RE: Engineers Certification For Josephine Jensen Apartment Fourplex (K22-D22H)

RE: Lot 23, Block A, La Cuesta Subdivision (K22-D2H)
(12009 Zia, NE) (Fourplex for Josephine Jensen)
ENGINEERS CERTIFICATION FOR CERTIFICATE OF OCCUPANCY
ENGINEERS STAMP DATED June 16, 2001
ENGINEERS CERTIFICATION DATED September 27, 2001

RE: ENGINEERS RECERTIFICATION- JENSEN 4-PLEX
LOCATED AT 12009 ZIA, NE
ZAP: K22, Drainage File K22/D22H

**RE: Engineers Certification For Josephine Jensen Apartment Fourplex (K22-D22H)
Dated August 1, 2001**

GRADING AND DRAINAGE PLAN
FOURPLEX APARTMENT FOR JOSEPHINE JENSEN
LOT 23, BLOCK "A"
LA CUESTA SUBDIVISION
ALBUQUERQUE, BERNALILLO COUNTY, NEW MEXICO

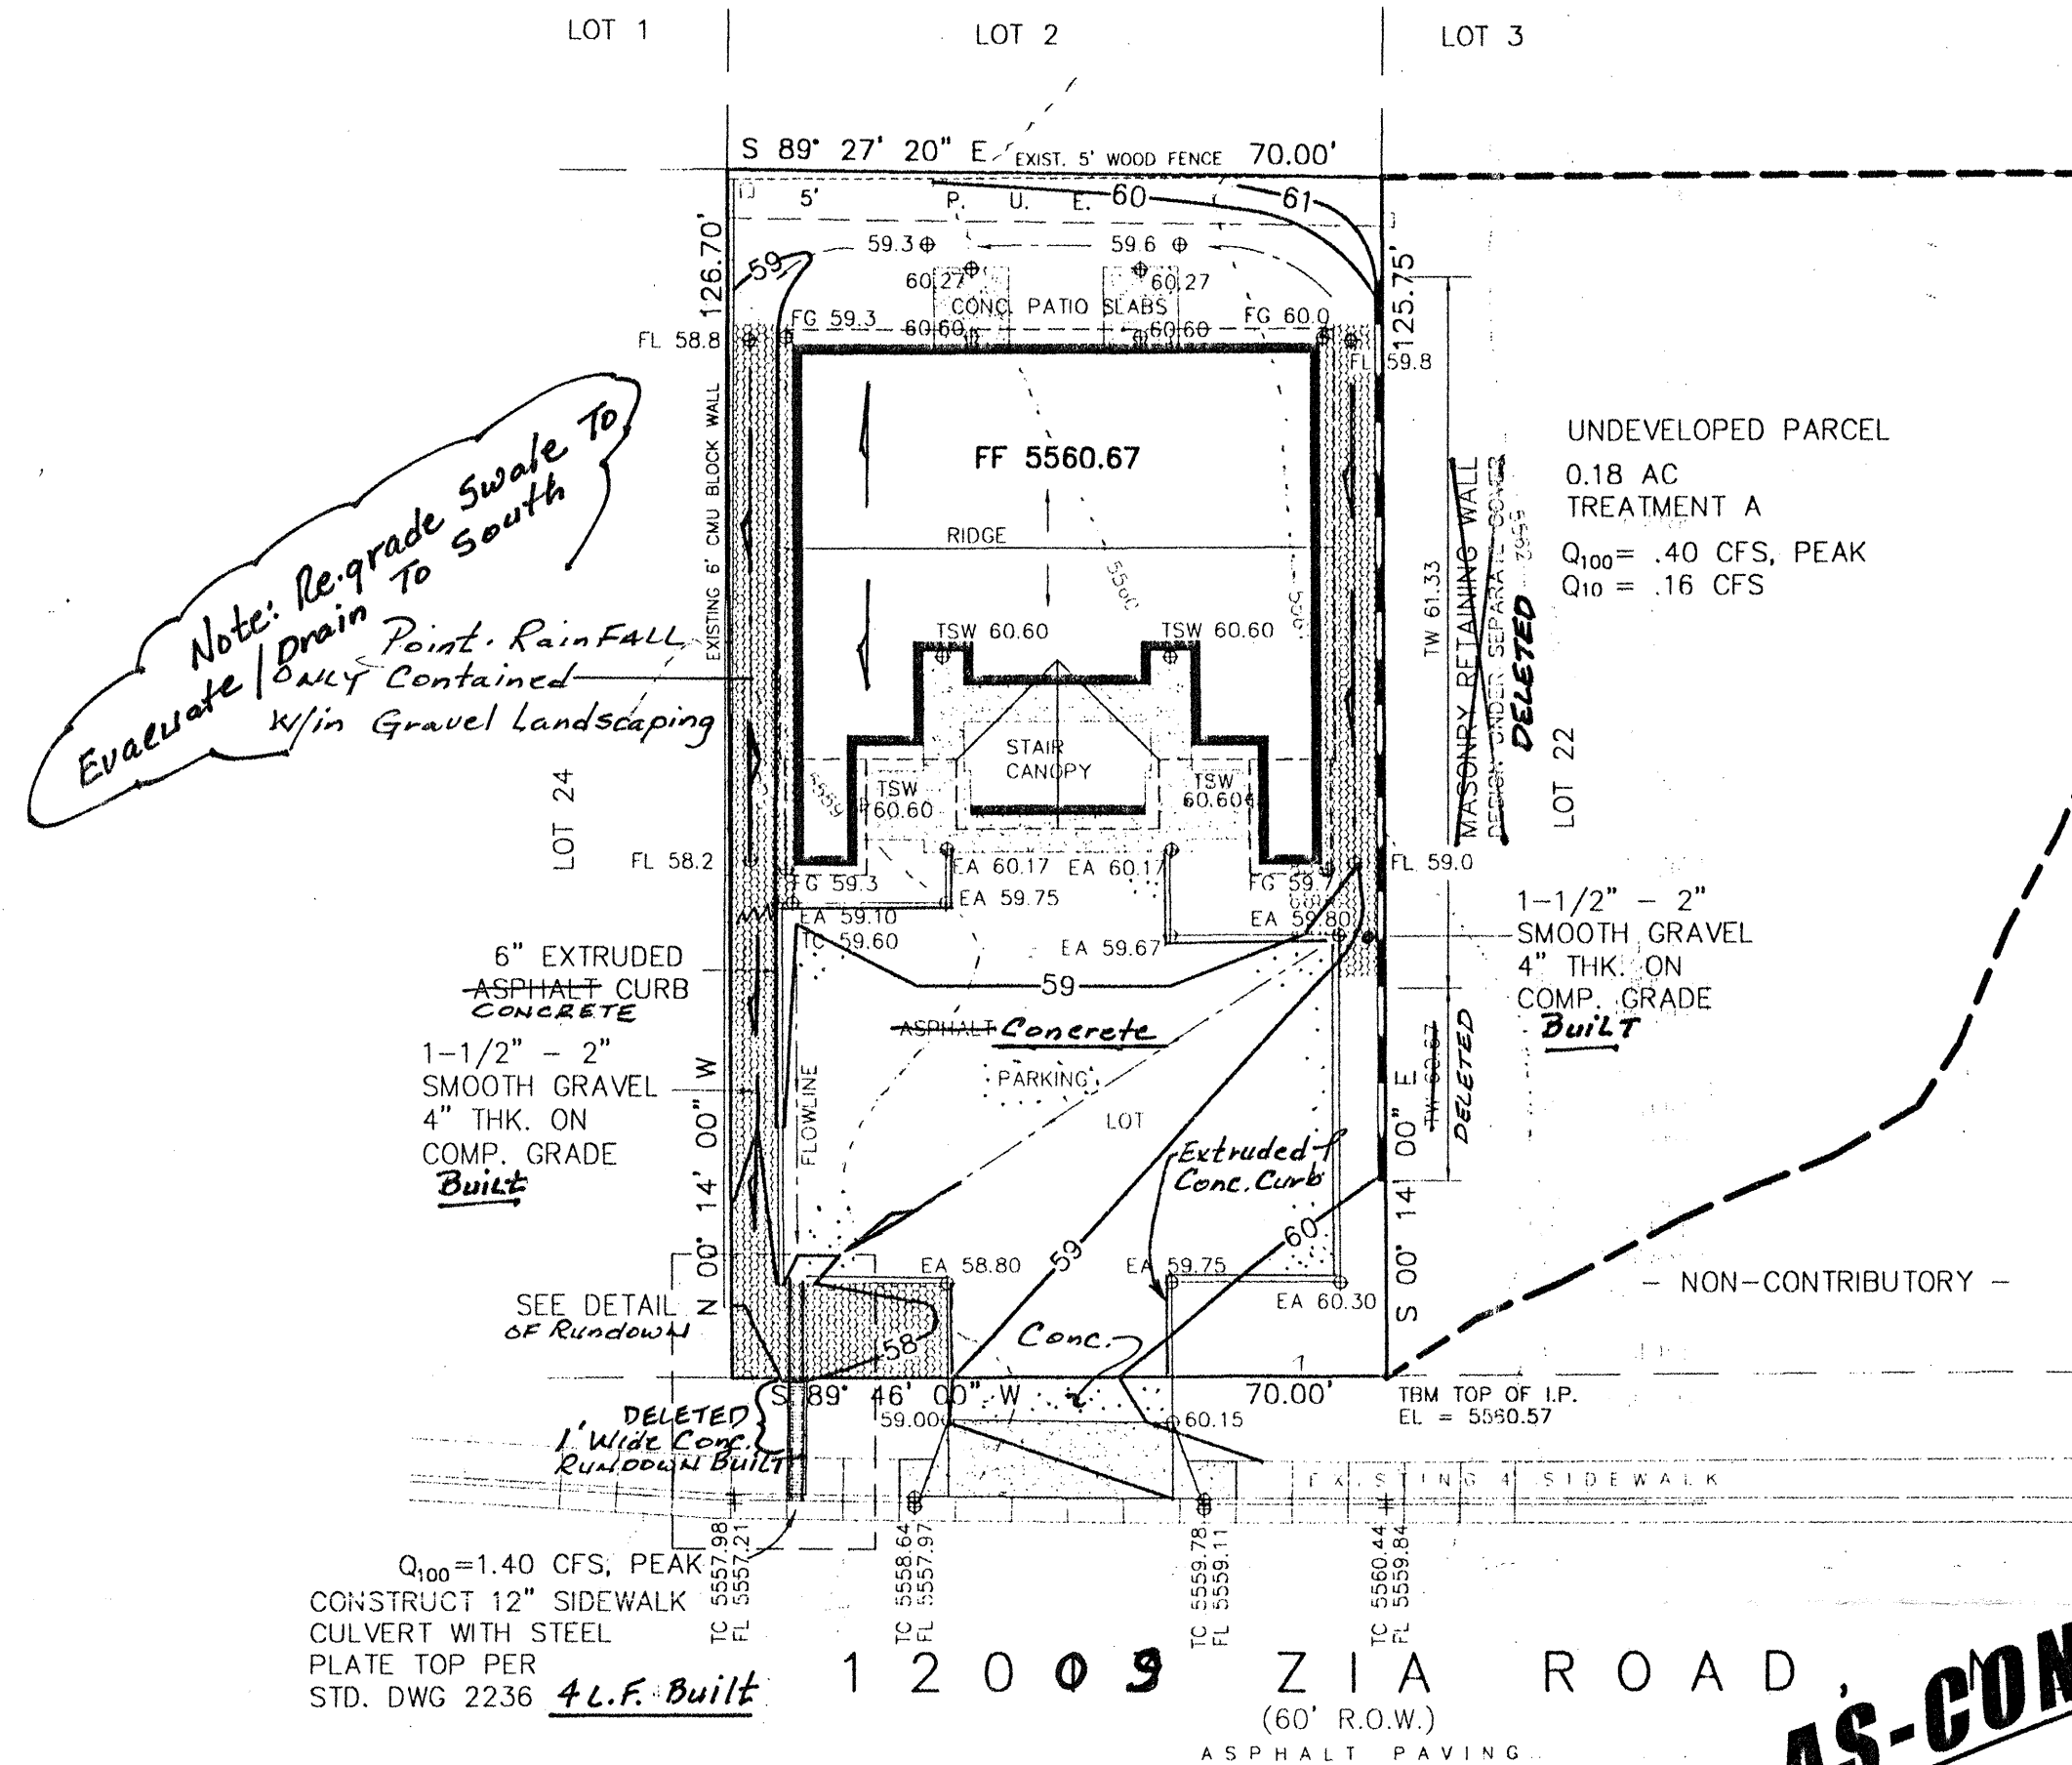
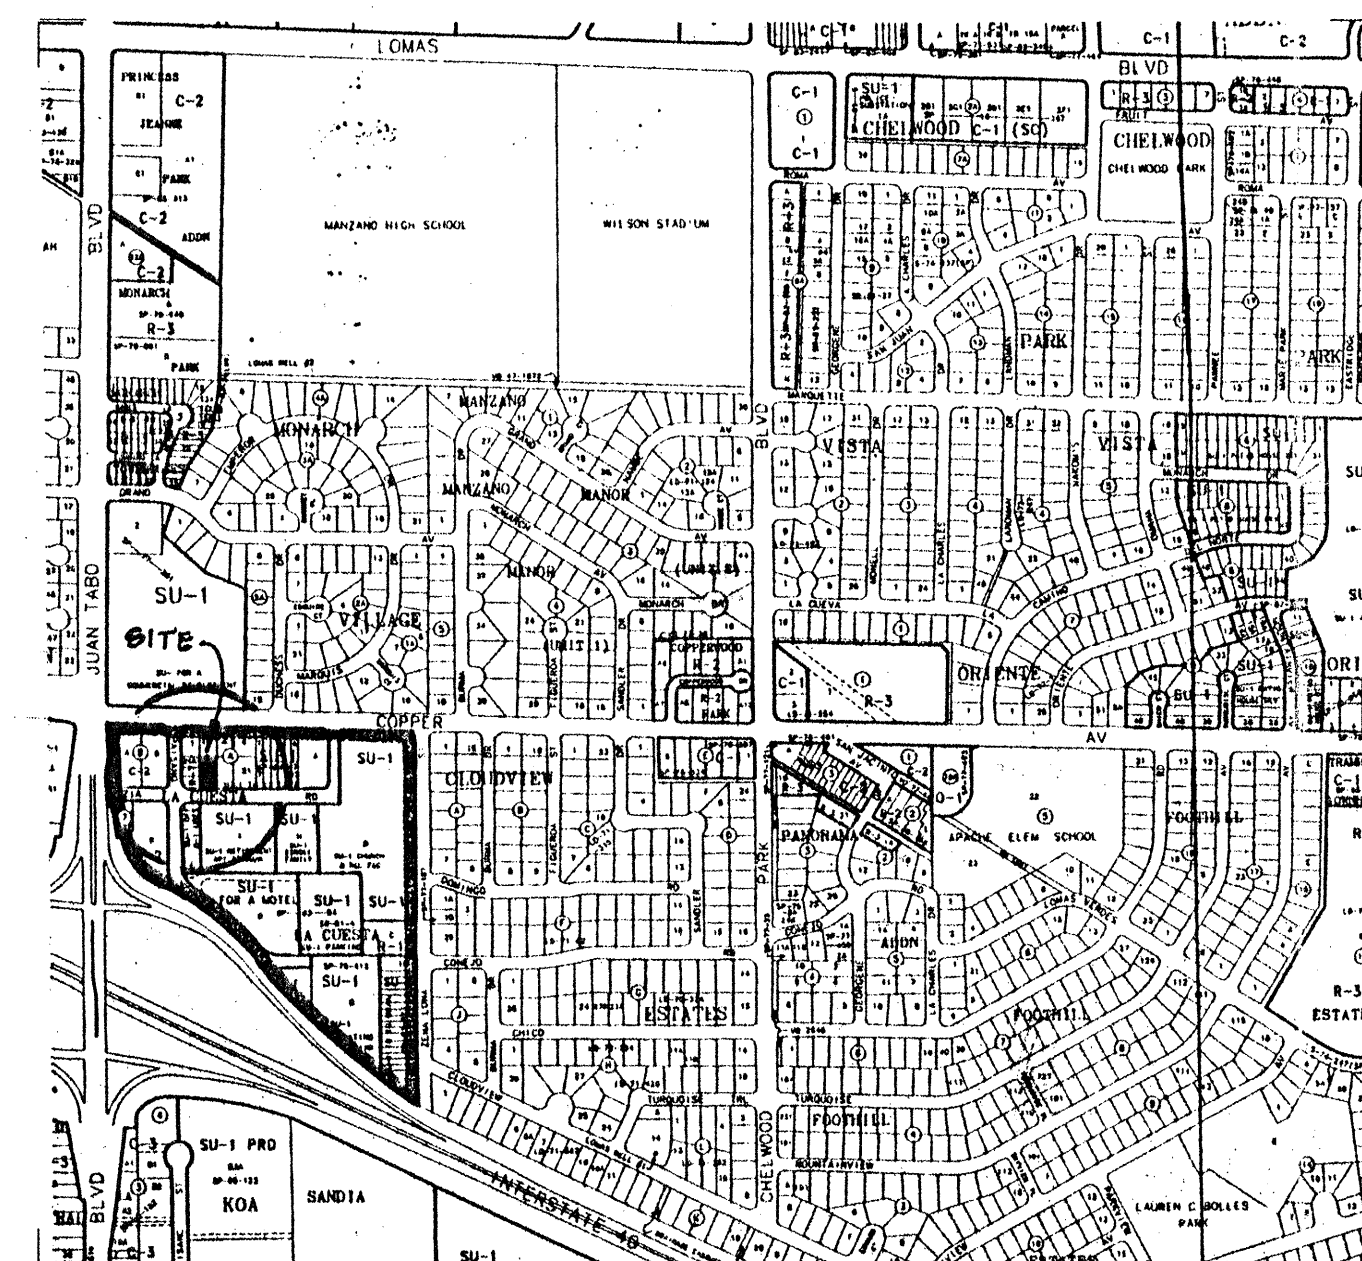
1. Teresa A. Martin's letter of September 10, 2001 still applies concerning the stamping of the engineer's signature on the engineer's stamp.
2. There was no masonry retaining wall on the east side of the property as indicated on the drawing.

3. The curb wall that was placed in the perimeter of the parking lot is blocking offsite flows. Offsite flows pond on the adjacent property to the east.

4. The asphalt parking lot call out should be changed to concrete parking lot.
5. Runoff from the north and west should drain to the street. However, the adverse grades do not allow this to occur. The runoff will just pond in the back or it will run into other peoples property.

- ~~6.~~ The sidewalk culvert indicates that the steel plate should cover the entire concrete channel. The plate only covers the sidewalk area. This is acceptable, but the drawing needs to be changed.

- ~~7.~~ The grades in the concrete parking lot need to be redone to show the new grades.
8. The west property line indicates that there is an existing six-foot CMU block wall. Soil has been placed on the apartment fourplex side up to a height of two to three feet. Is this wall a retaining wall?

Please find the attached "as-built" drawing based on a site inspection performed yesterday, September 27, 2001. I certify substantial compliance with the approved plan that was prepared by Raymond Hensley, P.E. Substitutions and deletions pursuant to your letter of 9/25/01 and confirmed by inspection are clearly noted on the "as-built".

As to your concerns, regarding the west property line wall, I do not see a problem allowing 2' of fill retainage against the CMU wall. This wall should be structurally adequate as long as moisture is not allowed to add to the lateral hydrostatic pore soil pressures. Therefore, a note is added, as a condition to regrade a swale positively to the south in accordance with your item 5.
